# MIL ON With DTC P0300 and/or Cold Start Misfire

YEAR(S)	MODEL(S)	ADDITIONAL INFORMATION
2017 - 2020	86

July 09, 2020 Rev1:

Figure 1. Location of Authorized Modifications Label on 2017 – 2020 86

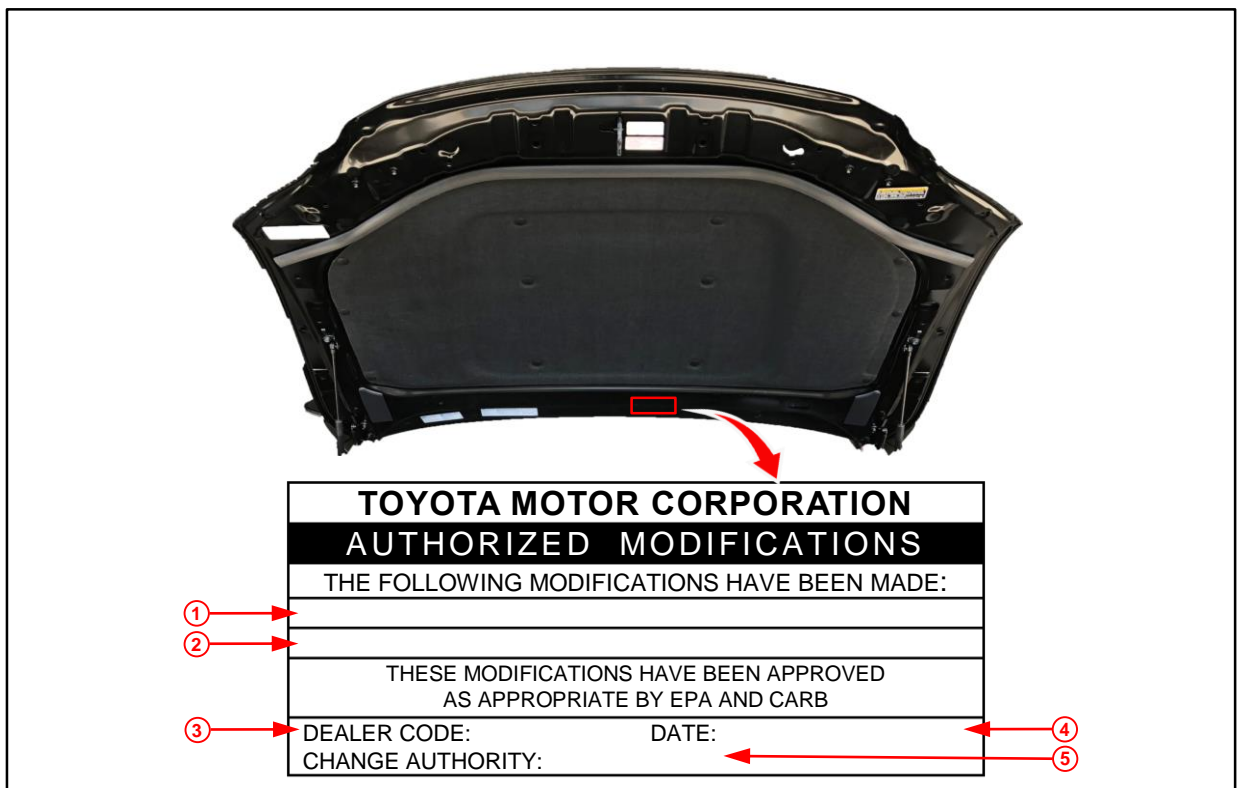
2. Check for the Authorized Modifications Label affixed to the vehicle in the location shown below. Confirm if the Engine ECU calibration has been updated.

4. Prepare and install the Authorized Modifications Label.
  - A. Using a permanent marker, enter the following information on the label:
    - Engine ECU part number [*Refer to the **Parts Information** section for the **NEW PART NUMBER***]
    - Calibration ID(s) [*Refer to the **Calibration Information** section for the **NEW CALIBRATION ID***]
    - Dealer Code
    - Repair Date
    - Change Authority [***This bulletin number***]
  - B. Affix the Authorized Modifications Label to the vehicle at the location shown in Figure 1. The Authorized Modifications Label is available through the MDC, P/N 00451-00001-LBL.
5. If possible, test-drive the vehicle from cold start at 50°F (10°C) to confirm the condition is no longer present.
